ZU1 SYSTEM BLOCK DIAGRAM

PROJECT : ZU1

Quanta Computer Inc.

Size	Document Number	Rev
	GMCH HOST(1 of 7)	3B
Date:	Tuesday, April 10, 2007	Sheet 5 of 39

Clock Generator

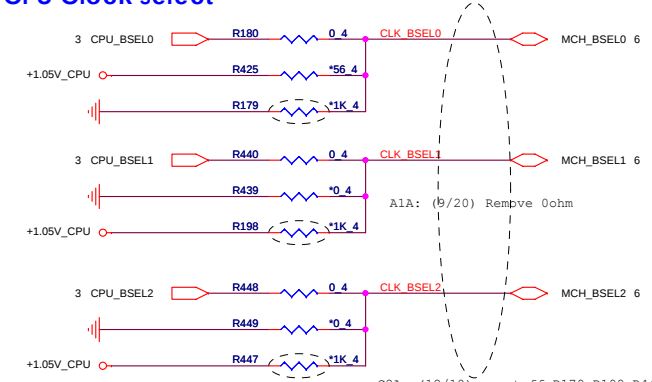
A1A: (9/24) ICS FAE suggest to change C542, C287 from 4.7uF to 10uF

A1A: (9/28) Reverse RC0603 footprint for EMI

A1A: (9/20) remove SATACLKREQ function, change R188 value from 475ohm to 22 ohm

A1A: (9/24) FAE : (14M_ICH and SIO_14M) signals trace should be equal length

A1A: (9/24) ICS FAE suggest R change from 22 to 33 ohm

A1A: (9/20) change R186 value from 33ohm to 22 ohm (Intel check list 1.301)

C2A: (12/26) Base on vendor-FCE suggestion, change C310/C299 from CH03306JB07 (33p) to CH02706JB06 (27p)

CPU Clock select

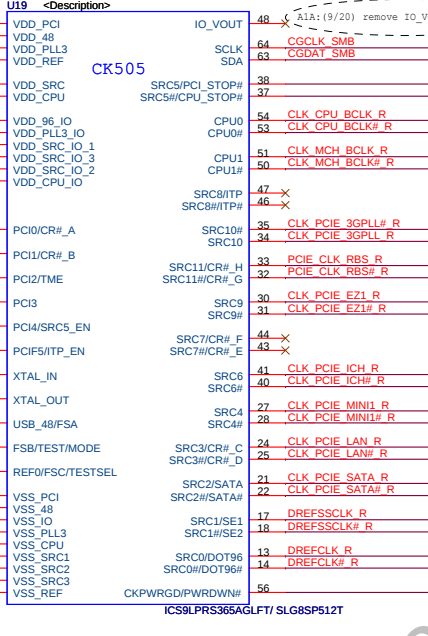
C2A: (12/10) no stuff R179, R198, R447 for auto CPU frequency selection (follow ZD1, Z01)

E3A: (3/16) Change C542 from 0805(CH6102K9A01) to 0603(CH6101K9905) base on ME request (HDD Mylar issue)

A1A: (9/24) Base on above table, SWAP SRC3 and SRC9

A1A: (9/24) Add PCIE_CLKREQ# PU to +3V

C2A: (12/12) change from +1.05V to +1.25V. Because VDD_IO will drop out when high loading

NB(HOST)

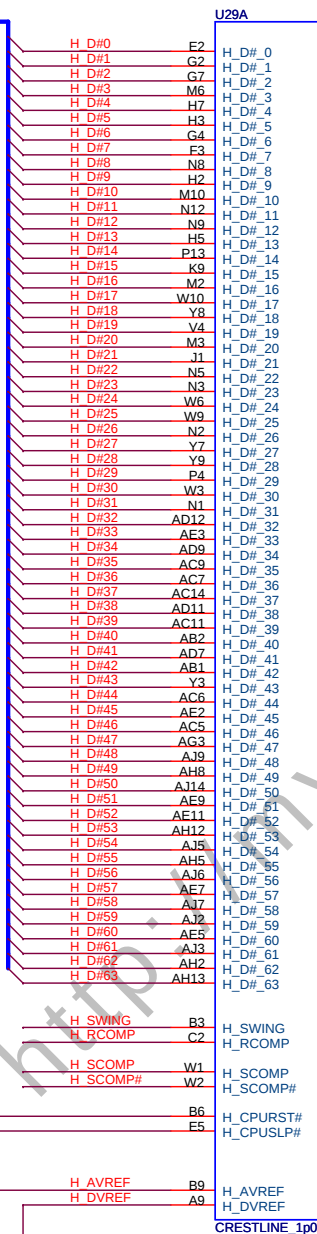
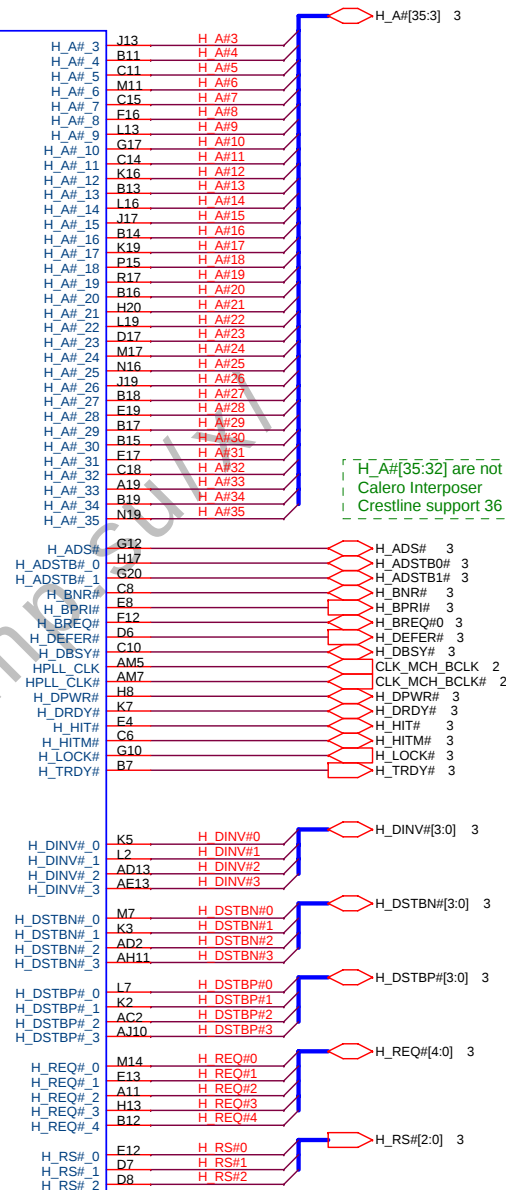
D3A: (2/1) Change 965GM from ES sample to QS sample
Change U29 P/N from AJ0QN120T37 to AJ0QP200T09

A1A: (9/20) remove R74 (0 ohm)

DDR2 Dual channel A/B PU

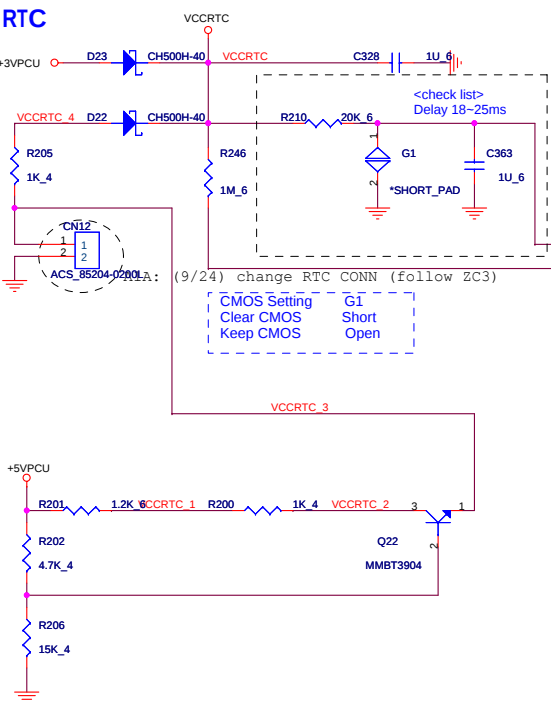
INTEL FAE (08/17)
ADD MA14 FOR DUAL LAYERS RAM

Giga LAN BCM5787M

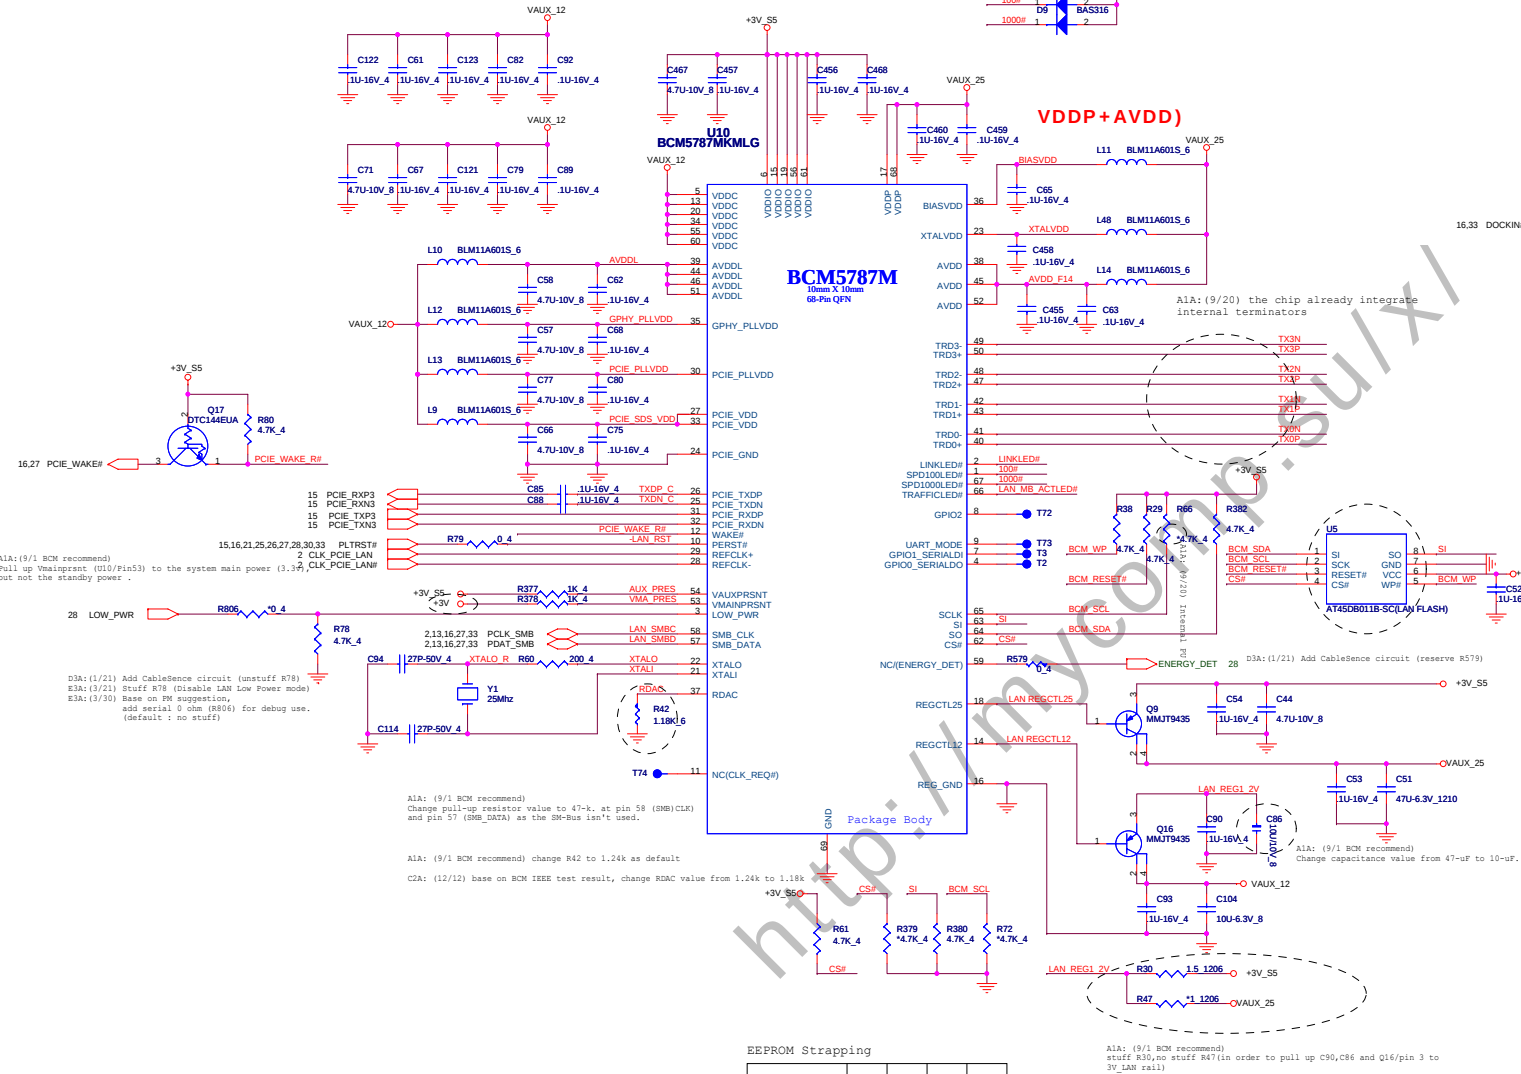
A1A: (9/27) Change +3V_LAN_S5 to +3V_S5

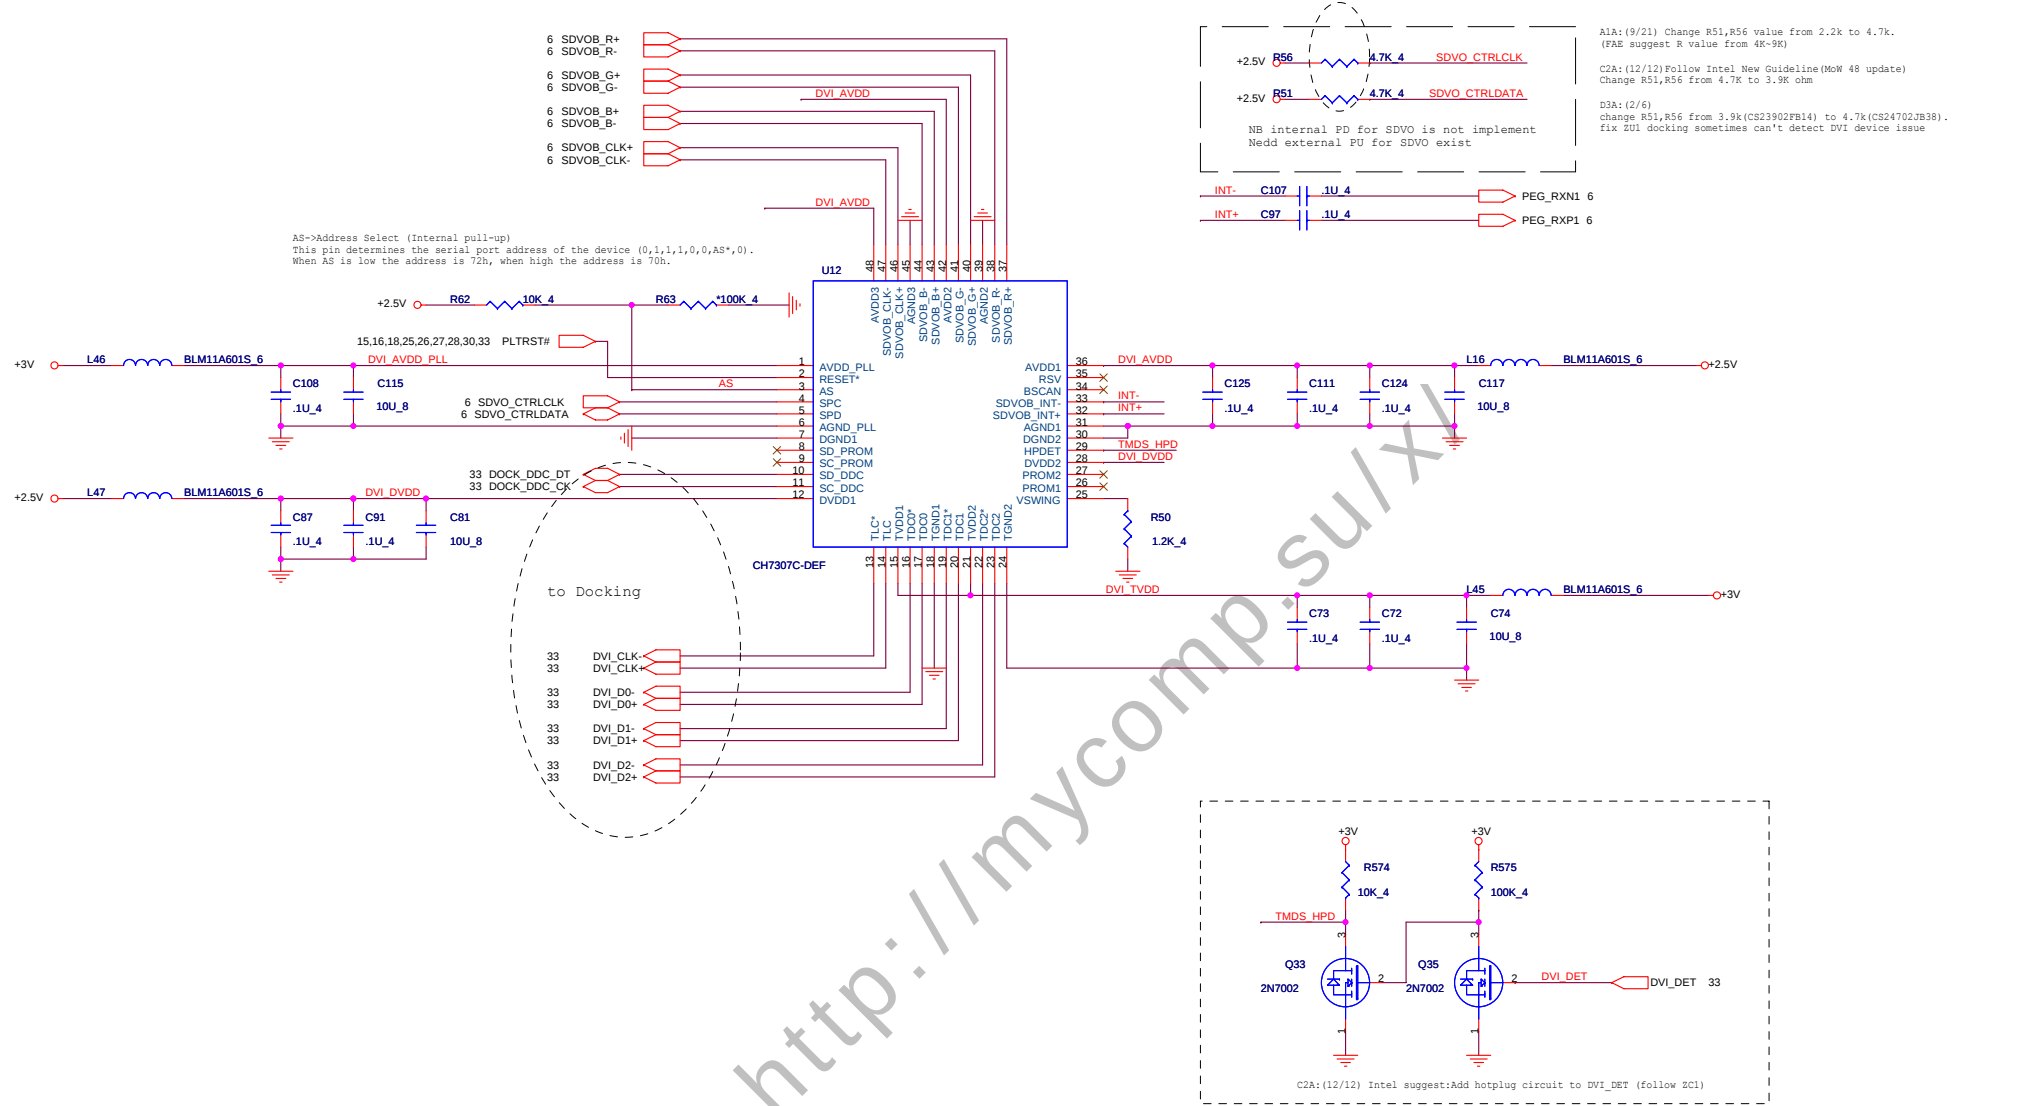
D3A: (1/30) remove U13, R68, R75, R73, C98
1/16 confirm with CHRONTEL FAE,
he said we can remove CH9901 (U13),
if ZU1 need support HDCP,
just need change controller from CH7307 to CH7313.
CH7313 already integrated HDCP function, no need external EEPROM.

INT K/B

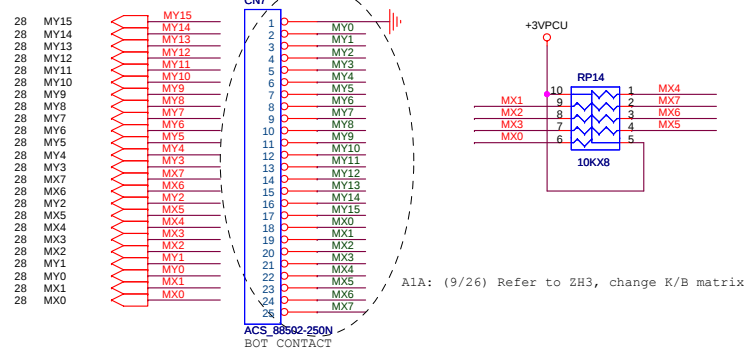
A1A: (9/26) Refer to ZH3, change K/B matrix

LED

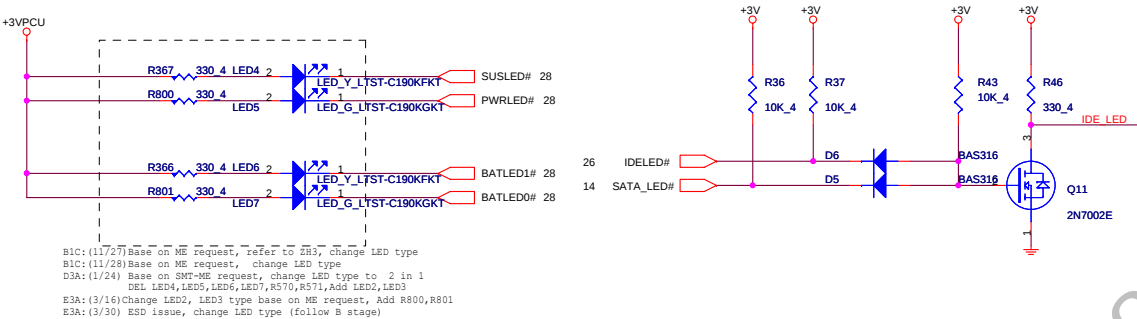
B1C: (11/27) Base on ME request, refer to ZH3, change LED type
B1C: (11/28) Base on ME request, change LED type
D3A: (1/24) Base on SMT-ME request, change LED type to 2 in 1
D3A: (1/24) LED4, LED5, LED6, LED7, R570, R571, Add LED2, LED3
E3A: (3/16) Change LED2, LED3 type base on ME request, Add R800, R801
E3A: (3/30) ESD issue, change LED type (follow B stage)

A1A: (10/30) no stuff (ZUI no support EMAIL LED)
E3A: (3/30) Remove Q27, R1 footprint to save space for layout
ZUI no support E-Mail LED

LINE OUT Amplifier

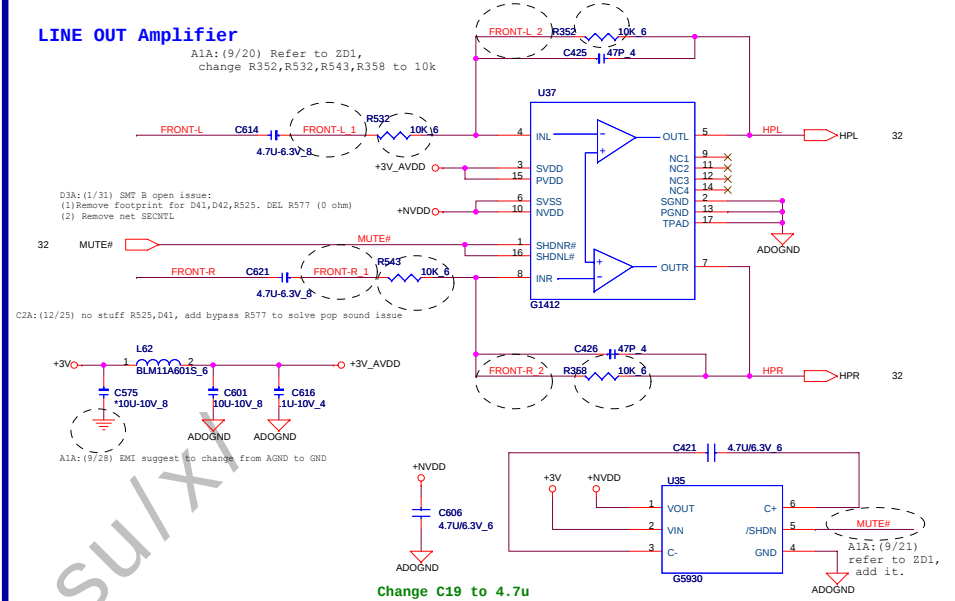
A1A: (9/20) Refer to ZD1,
change R352,R532,R543,R358 to 10k
